Re: Turkey Point Unit 3 and Unit 4
Docket Nos. 50-250 and 50-251
Florida Power and Light Company's, Turkey Point Units 3 and 4, First Six-Month Status Report in Response to March 12, 2012 Commission Order Modifying Licenses with Regard to Requirements for Mitigation Strategies for Beyond-Design-Basis External Events (Order Number EA-12-049)

First Six Month Status Report for the Implementation of Order EA-12-049

Modifications Nos. 2 and 3

Modification No. 7 (Unit 3 Shown, Unit 4 similar)

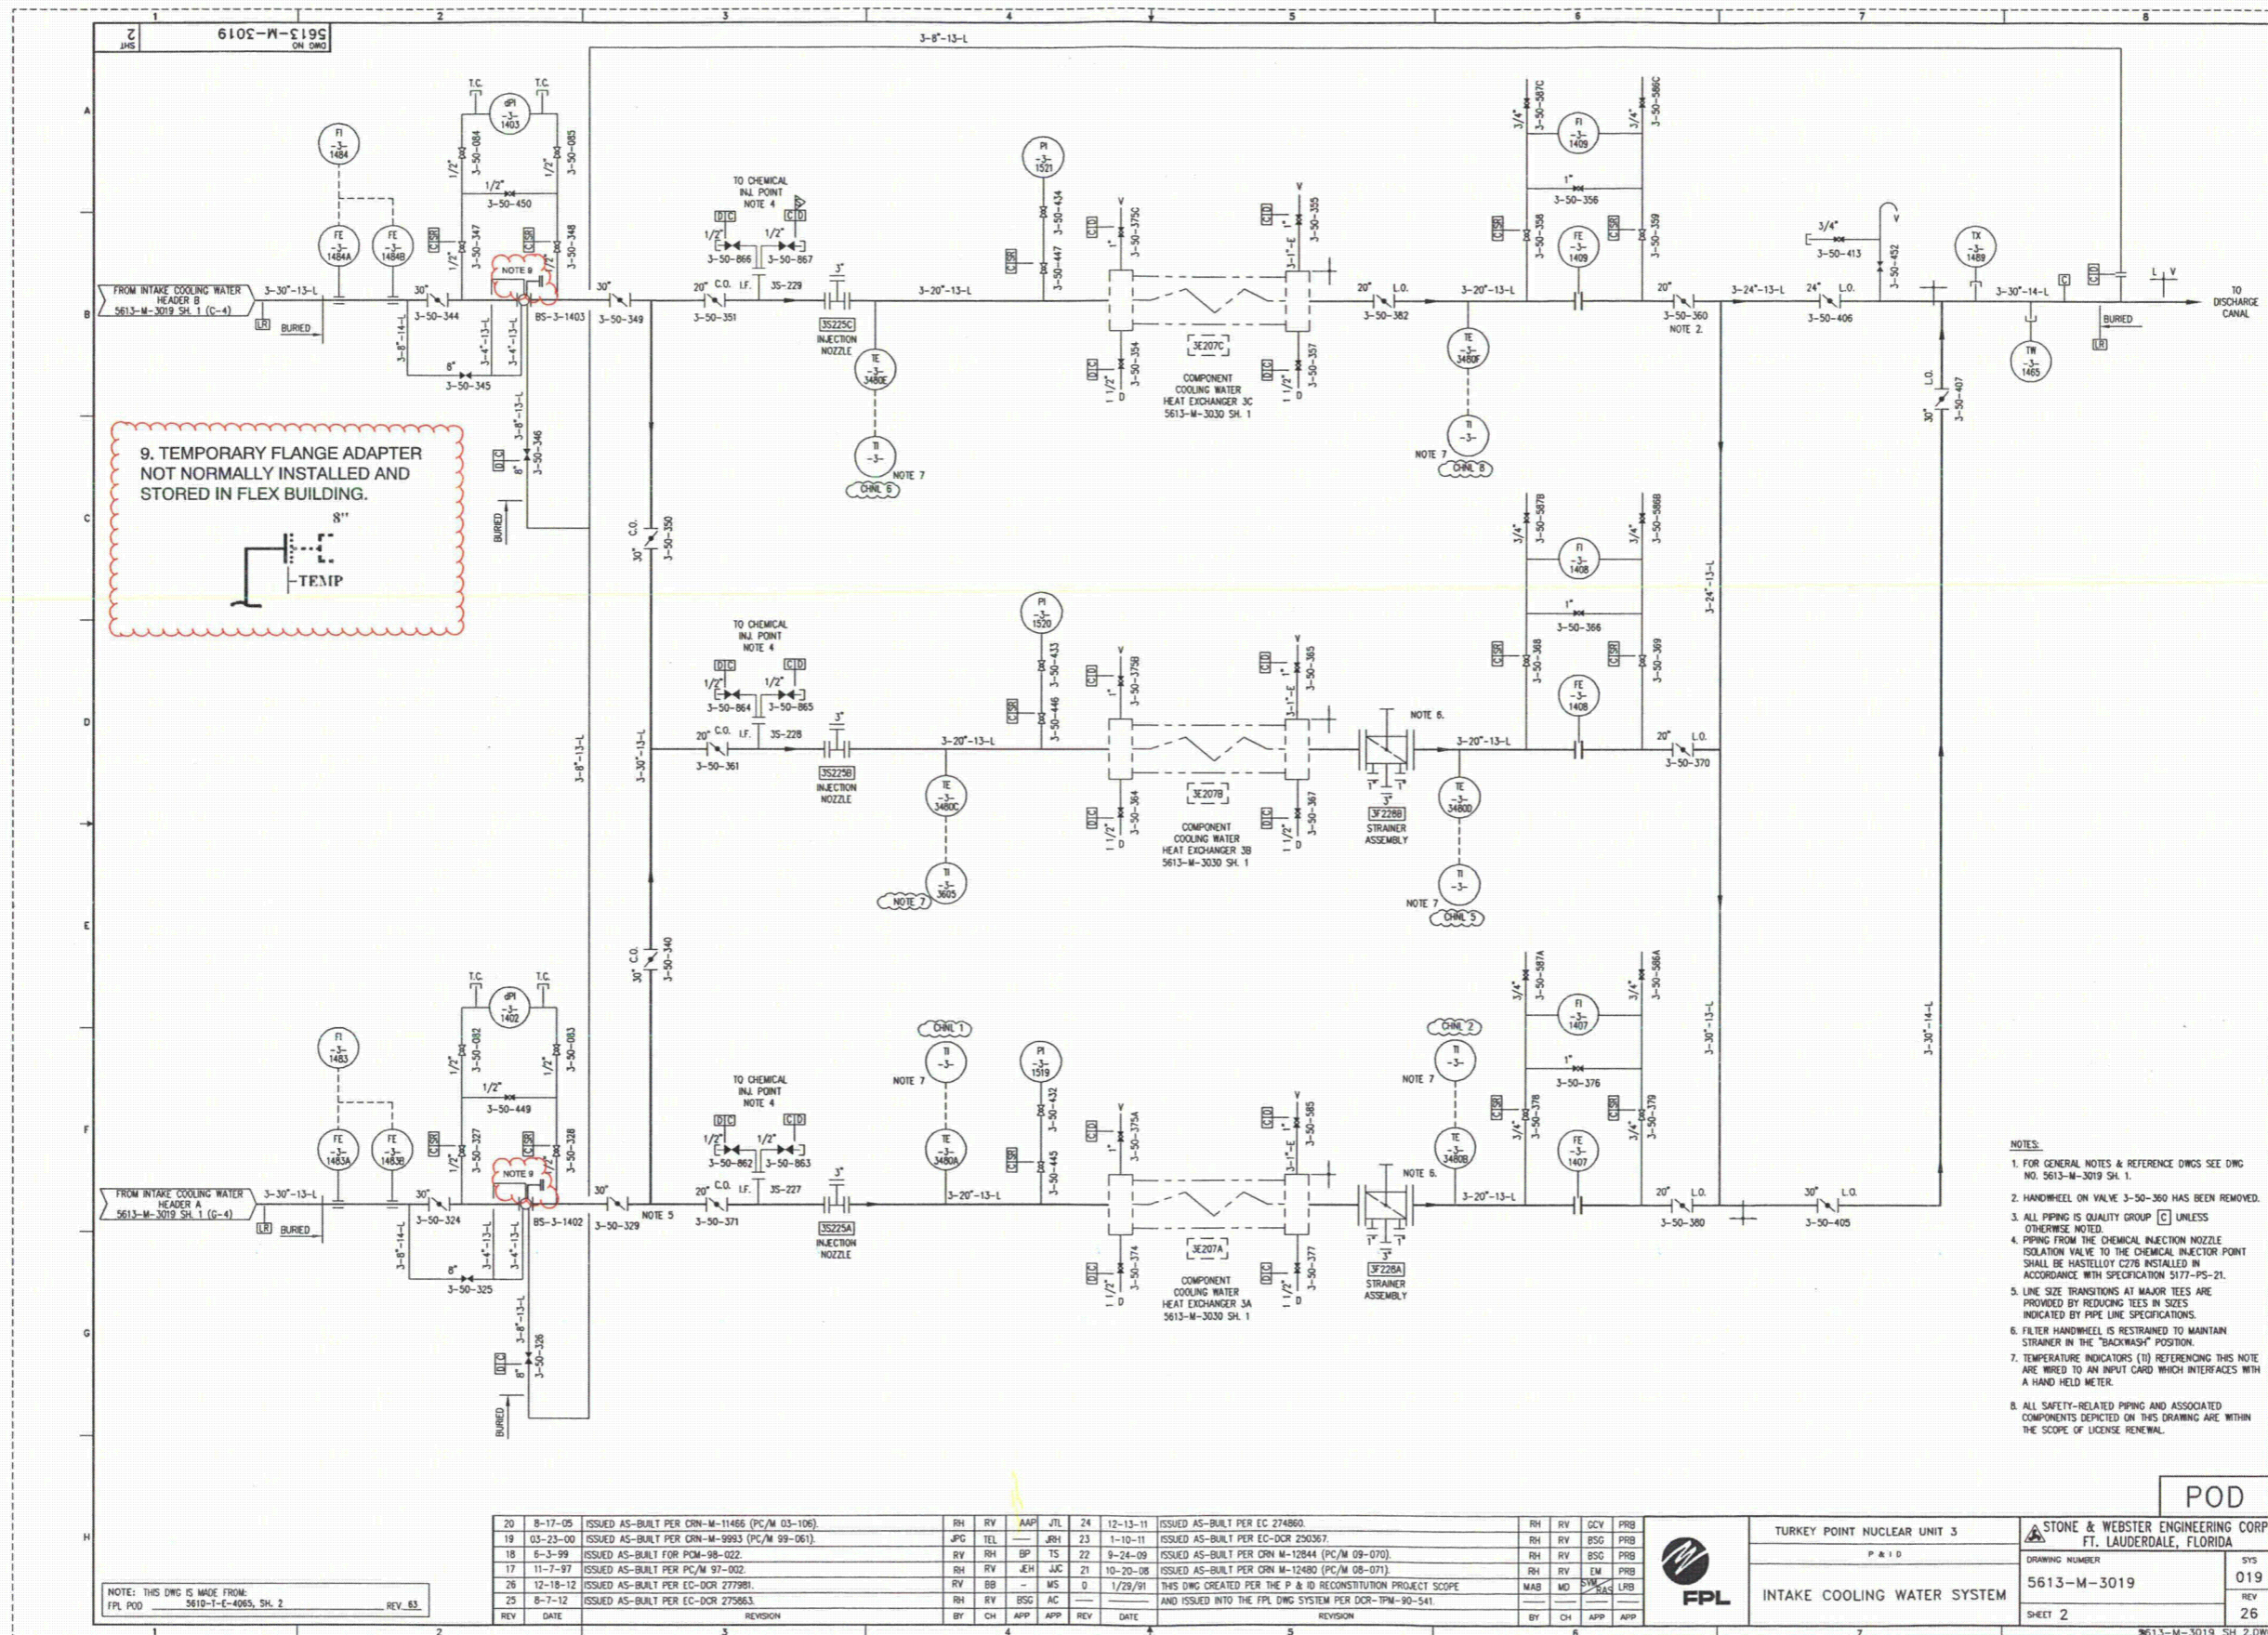
The Overall Integrated Plan submittal (Reference 1, Attachment 4) included a sketch showing a new hose connection point to the Intake Cooling Water line to the A TPCW heat exchanger strainer backflush piping for use during Phase 3 (Modification No. 7). Due to constructability and operational concerns, the current plans are to install a flanged connection in each of the ICW strainer cover to both the A and B CCW heat exchanger instead of the A TPCW heat exchanger. The flanged connection will allow connection of a hose from the ICW FLEX pump. A revised conceptual modification sketch has been provided in Attachment 3. This change will not affect the strategy or the ability to maintain core cooling and heat removal by equipment credited during Phase 3.

DRAWING NUMBER: 5613-M-3033
SHEET 1

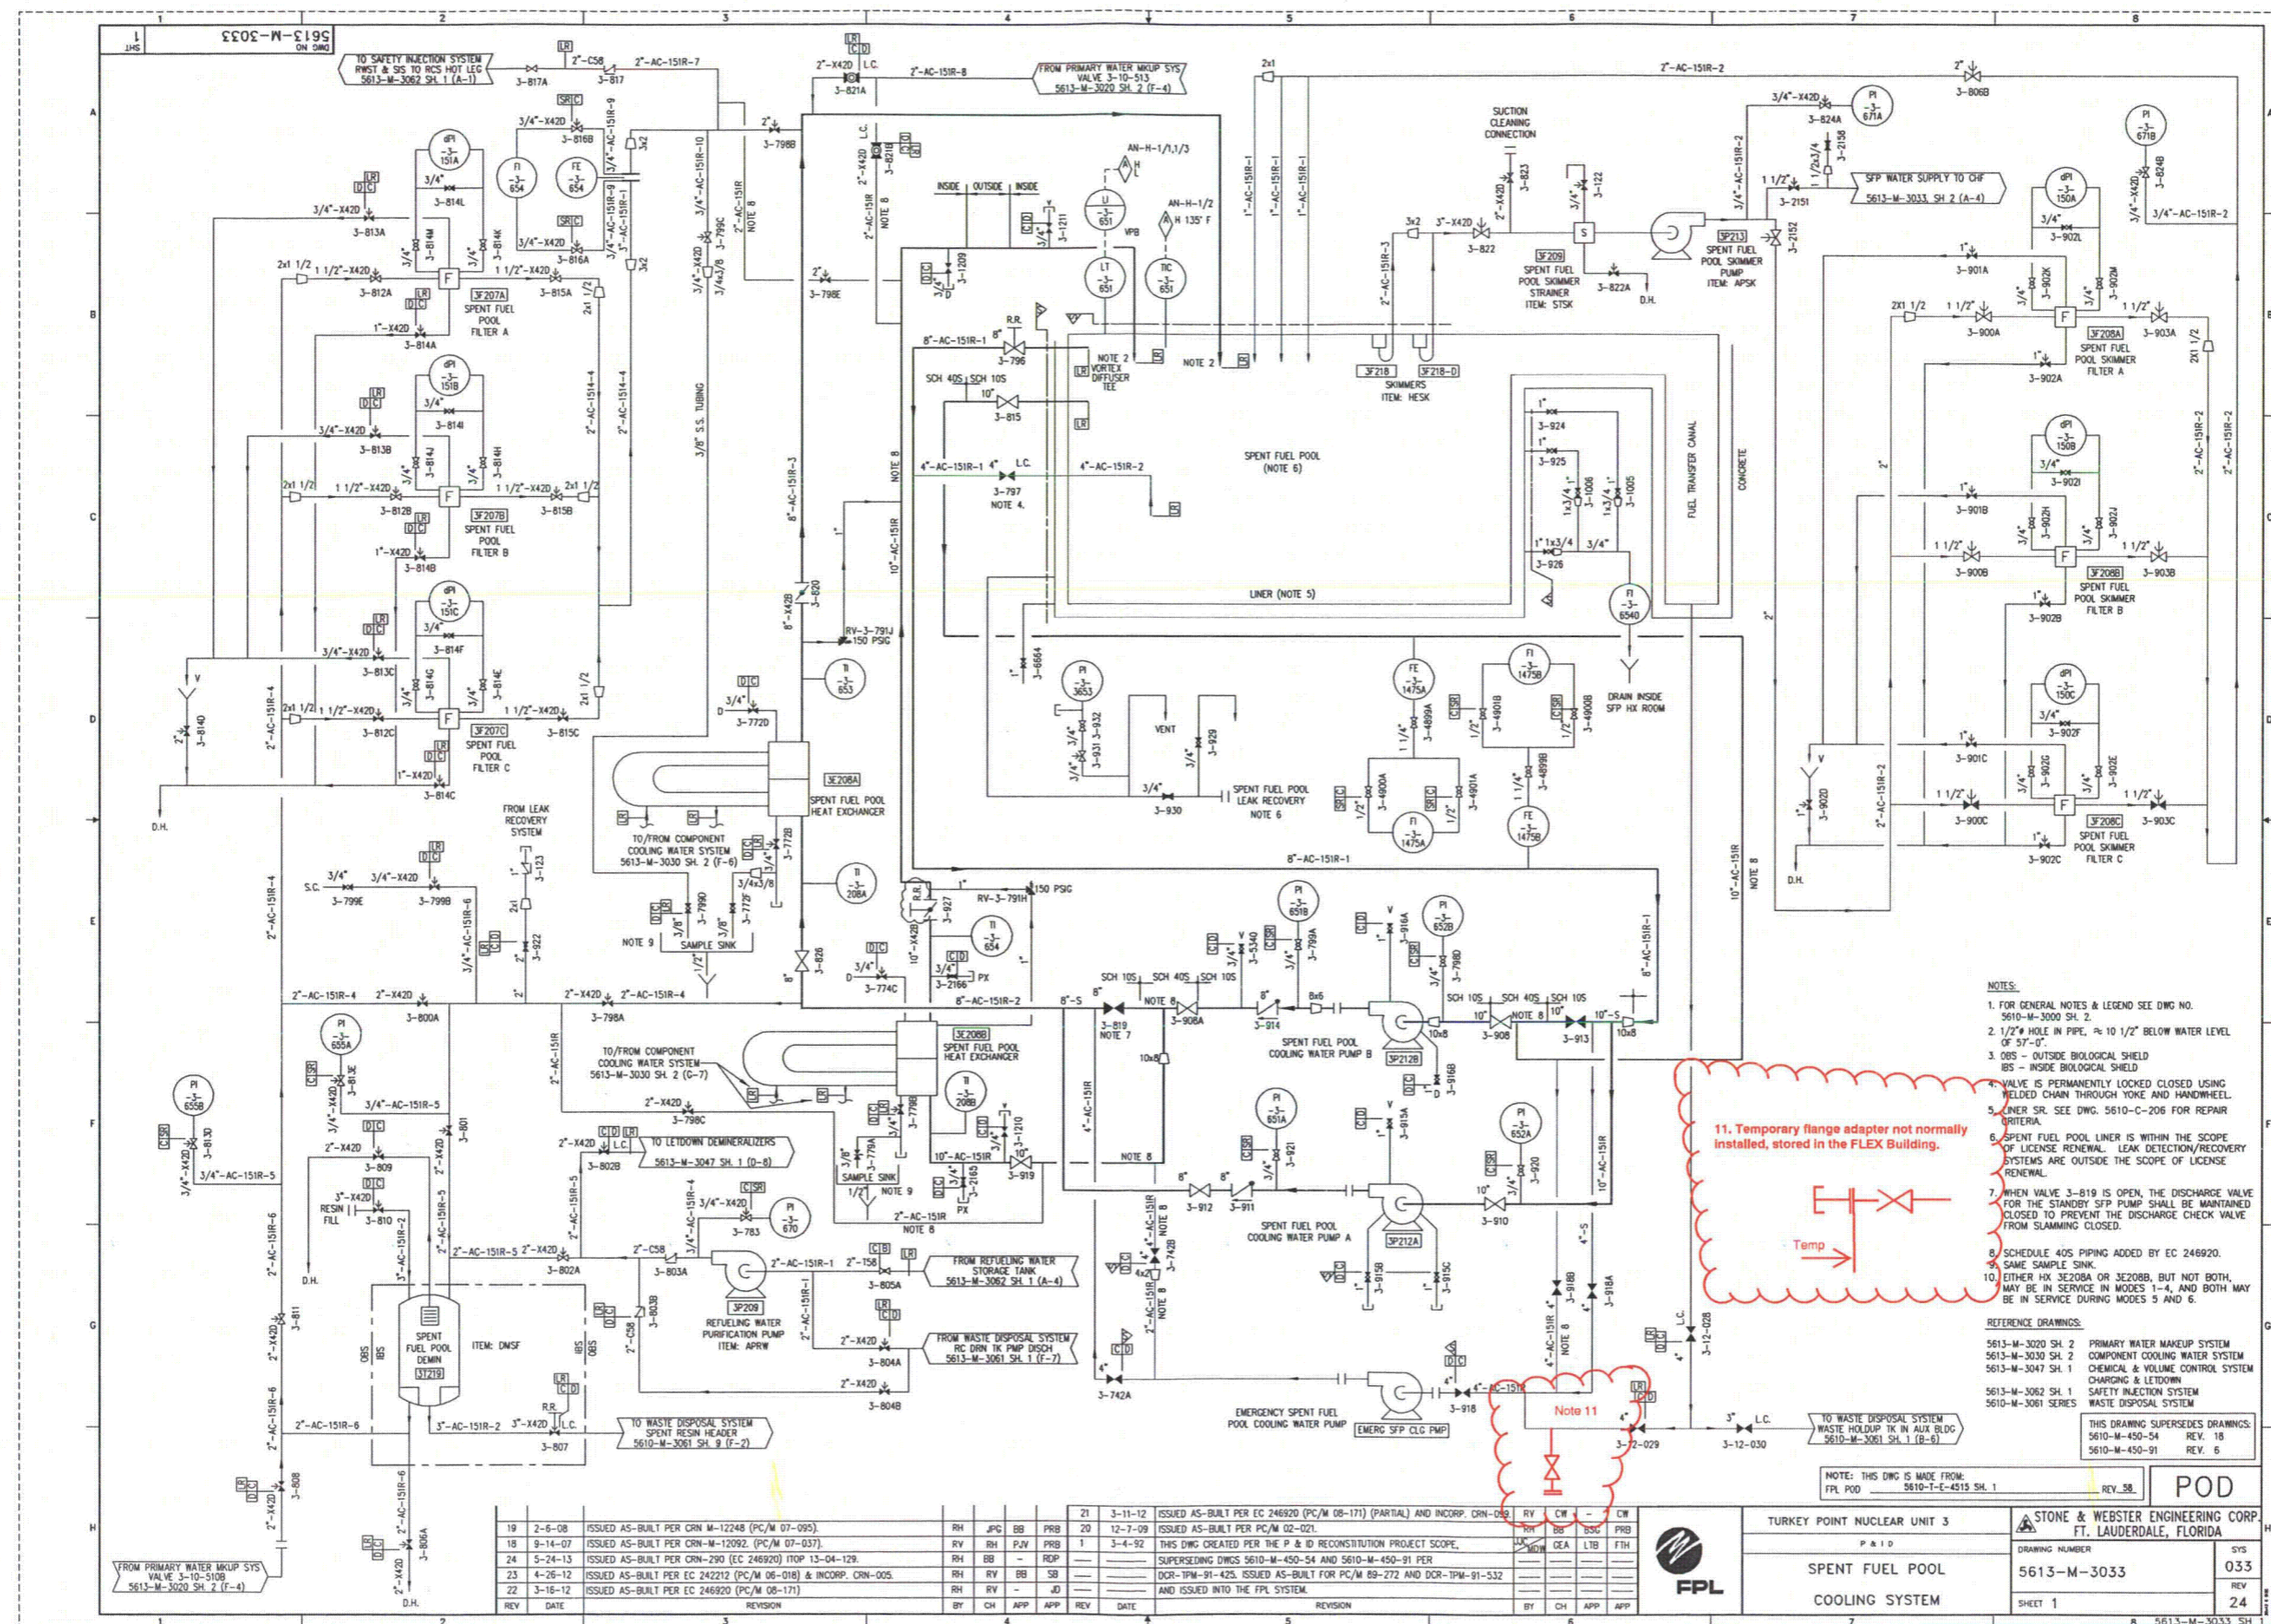
The Overall Integrated Plan submittal (Reference 1, Attachment 4) included a sketch showing a new connection point to the Spent Fuel Pool (SFP) discharge for use during Phase 2 (Modification No. 8). Due to constructability and operational concerns, the current plans are to install an isolation valve and hose connection in the SFP emergency pump suction line. The purpose of this connection is to allow adding water to the SFP in the event high dose rates do not allow approaching the pool with a hose. Either the suction or discharge connections to the SFP can provide this capability. A revised conceptual modification sketch has been provided in Attachment 4. This change will not affect the strategy or the ability to provide makeup to by equipment credited during Phase 2.
